SEQUOYAH NUCLEAR PLANT (SQN) UNITS 1 AND 2, AND WATTS BAR NUCLEAR PLANT (WBN) UNIT 1 RESPONSE TO NRC BULLETIN 2001-01, "CIRCUMFERENTIAL CRACKING OF REACTOR PRESSURE VESSEL HEAD PENETRATION NOZZLES," DATED AUGUST 3, 2001

**SEQUOYAH NUCLEAR PLANT (SQN) UNITS 1 AND 2 RESPONSE TO  
NRC BULLETIN 2001-01, "CIRCUMFERENTIAL CRACKING OF REACTOR PRESSURE  
VESSEL HEAD PENETRATION NOZZLES"**

**WATTS BAR NUCLEAR PLANT (WBN) UNIT 1  
RESPONSE TO  
NRC BULLETIN 2001-01, "CIRCUMFERENTIAL CRACKING OF REACTOR PRESSURE VESSEL  
HEAD PENETRATION NOZZLES"**

General Arrangement In Upper Reactor Cavity Area  
(Unit 1 is shown. Unit 2 is opposite hand.)

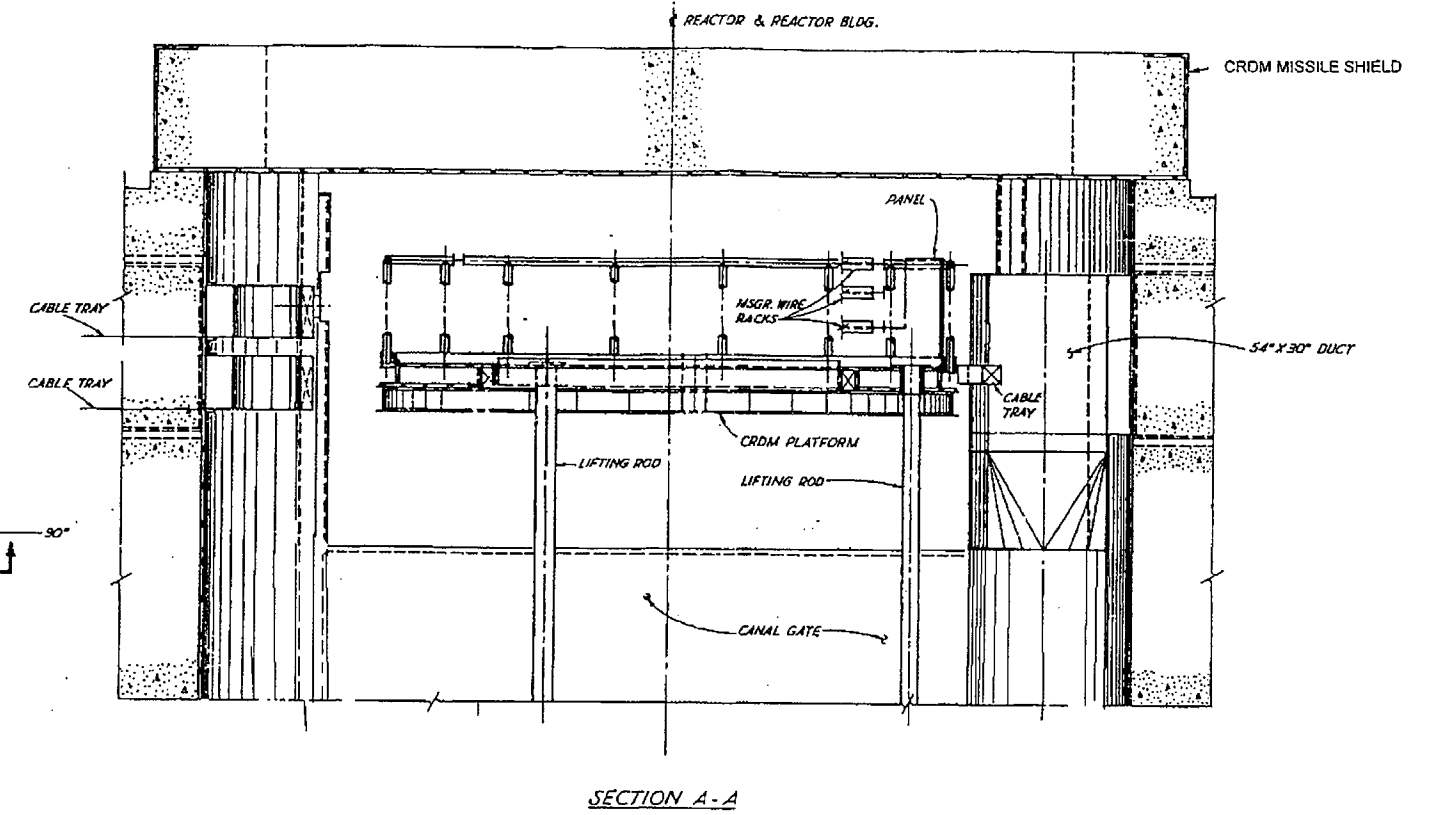
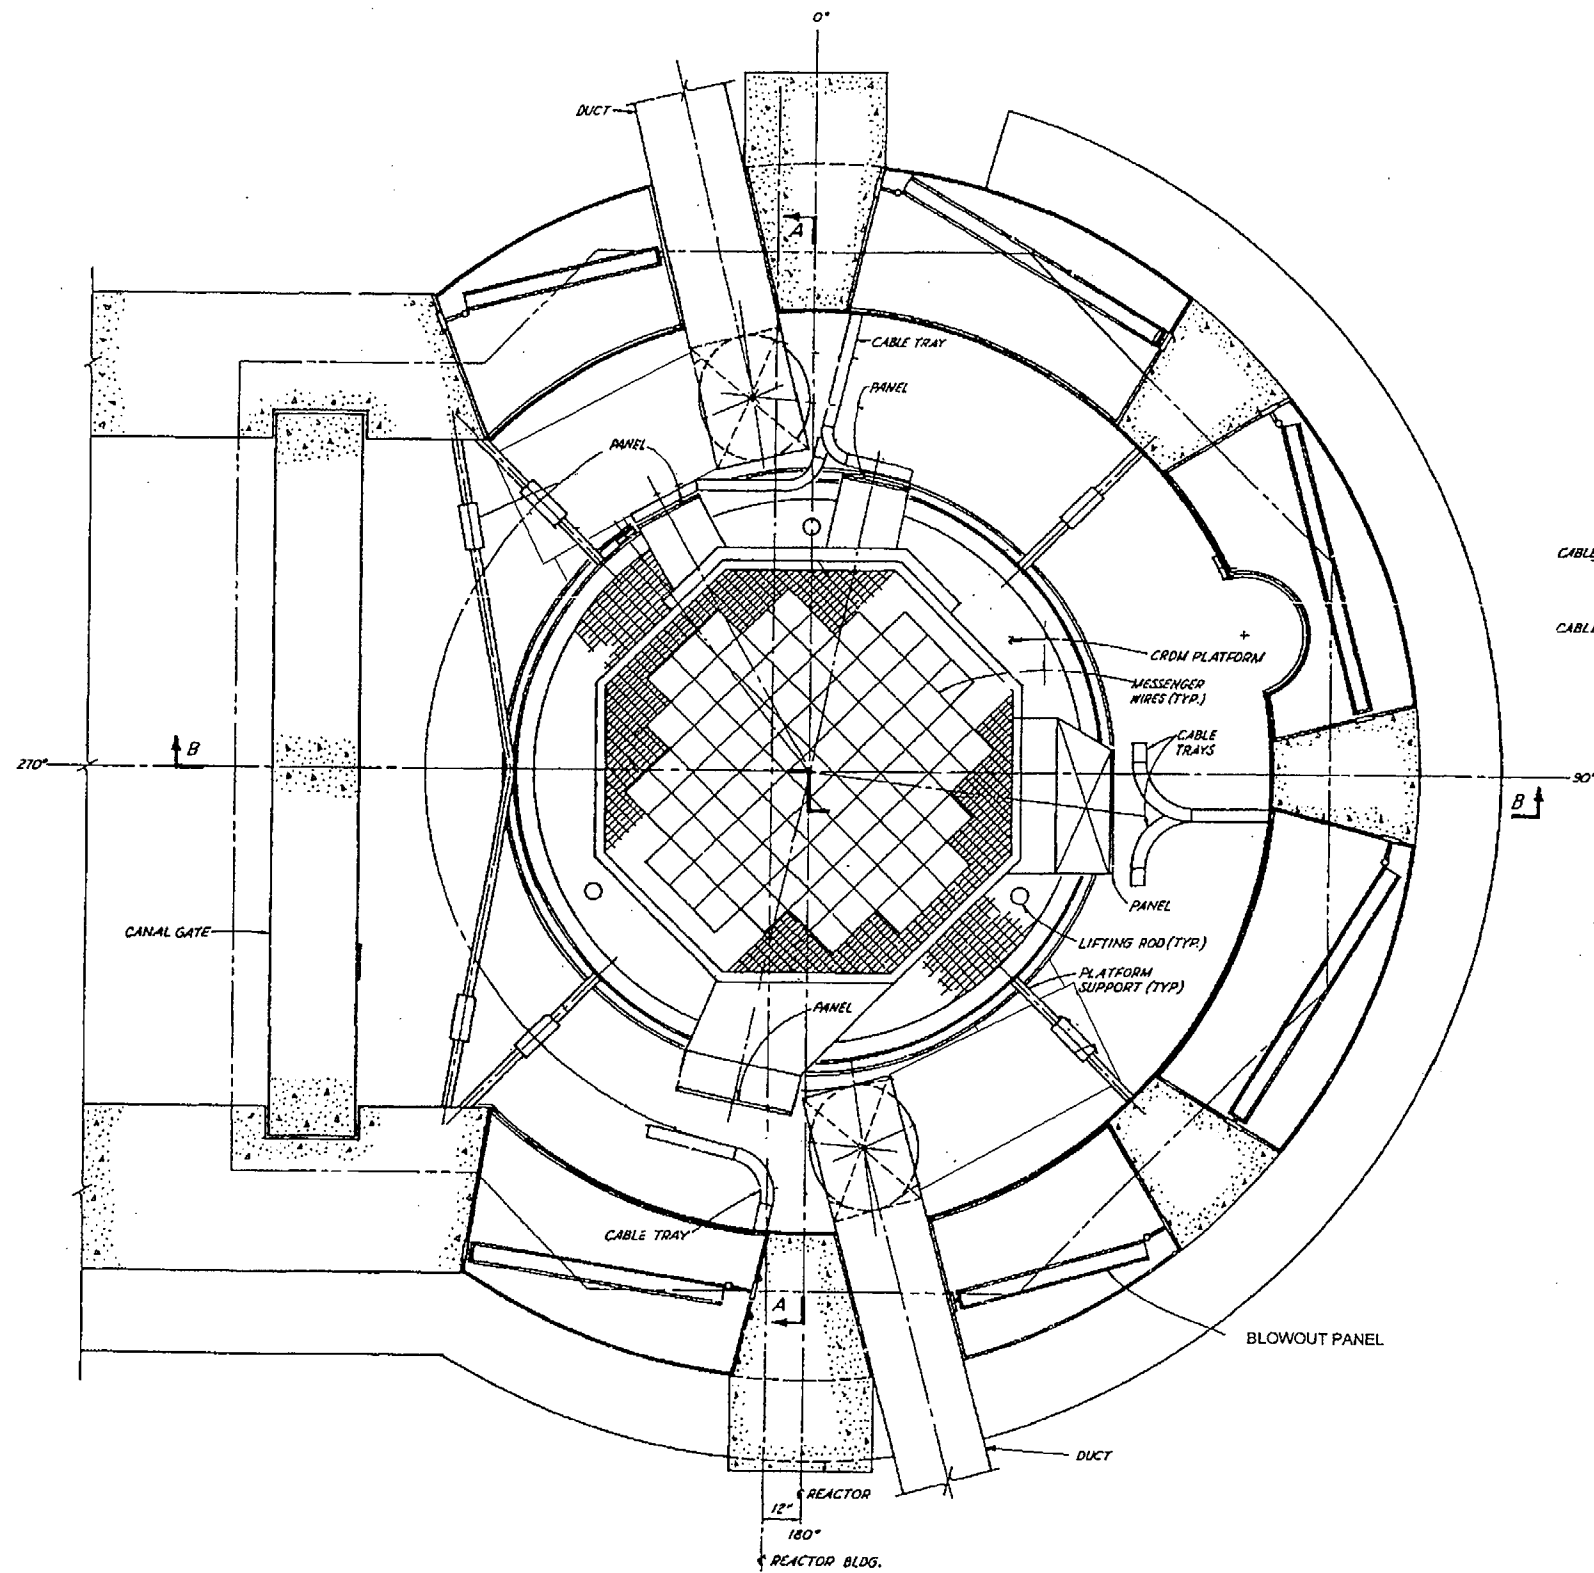
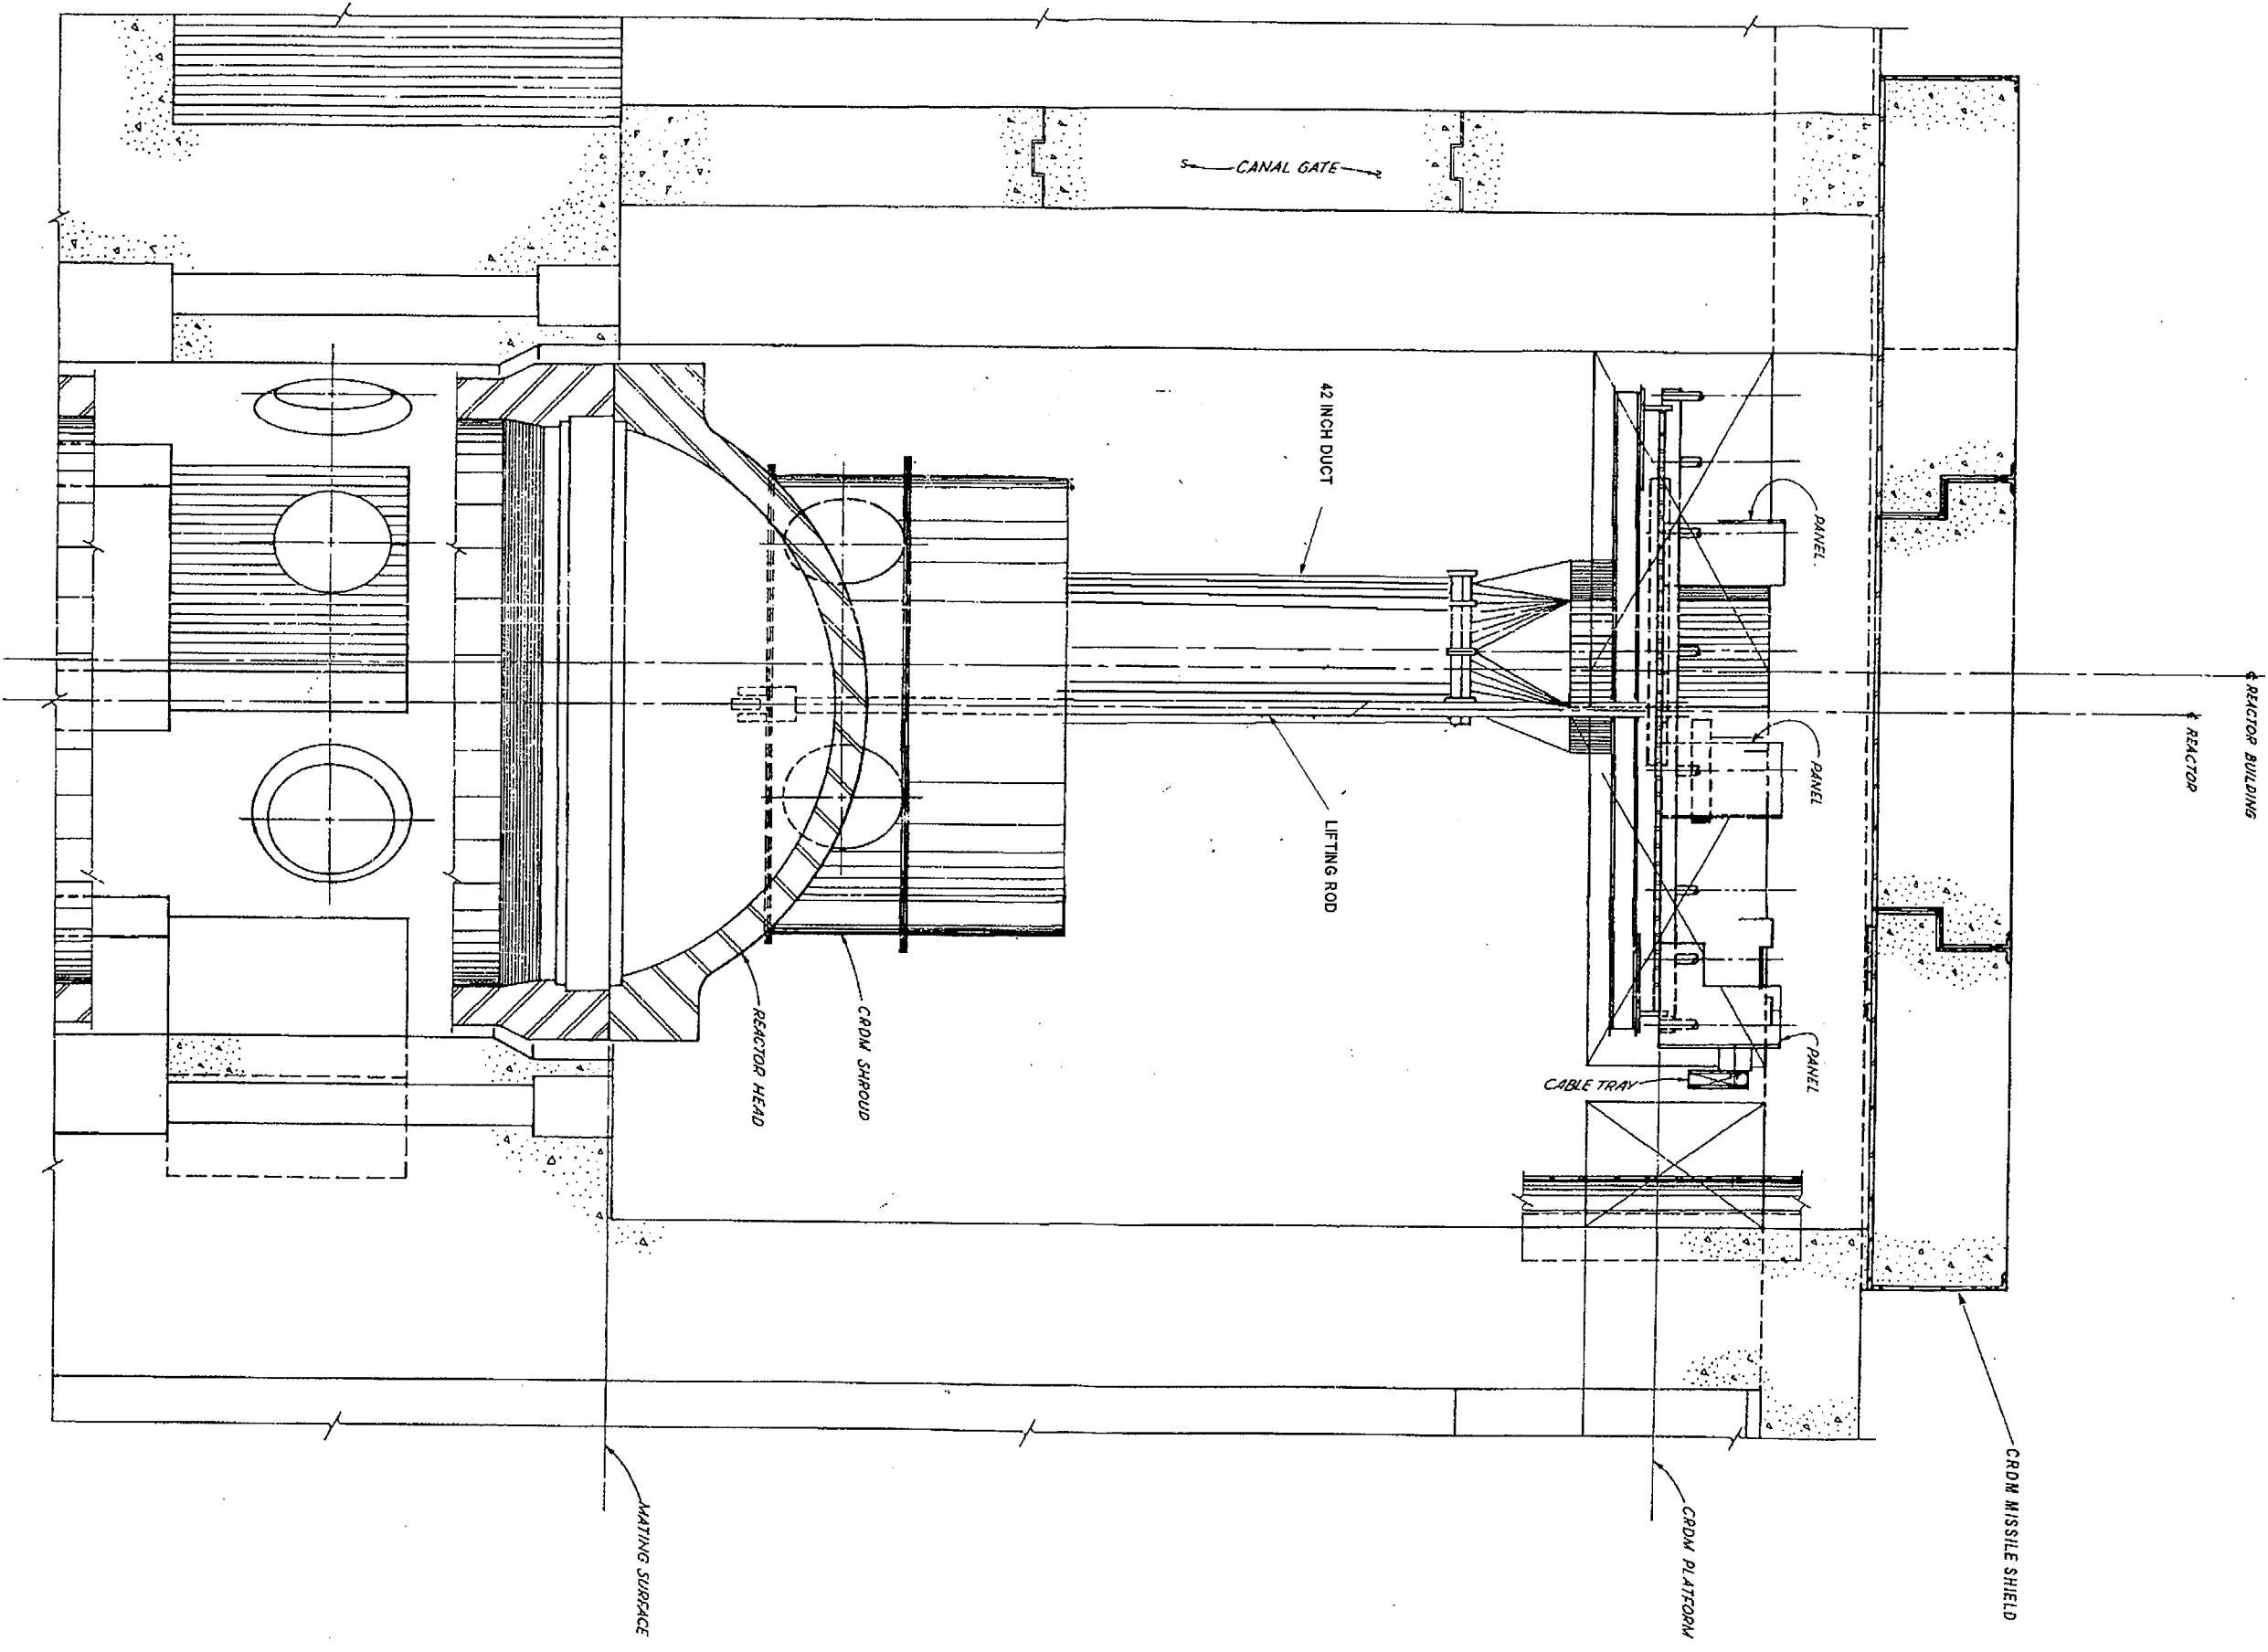
- e. a description of the configuration of the missile shield, the CRDM housings and their support/restraint system, and all components, structures, and cabling from the top of the RPV head up to the missile shield. Include the elevations of these items relative to the bottom of the missile shield.

Enclosure 1, Attachment 1 provides a table that contains the general description of the components within the area of the upper reactor cavity between the RPV head and the CRDM missile shields. Refer to Enclosure 1, Attachment 2 for a sketch of the general arrangement in this area.
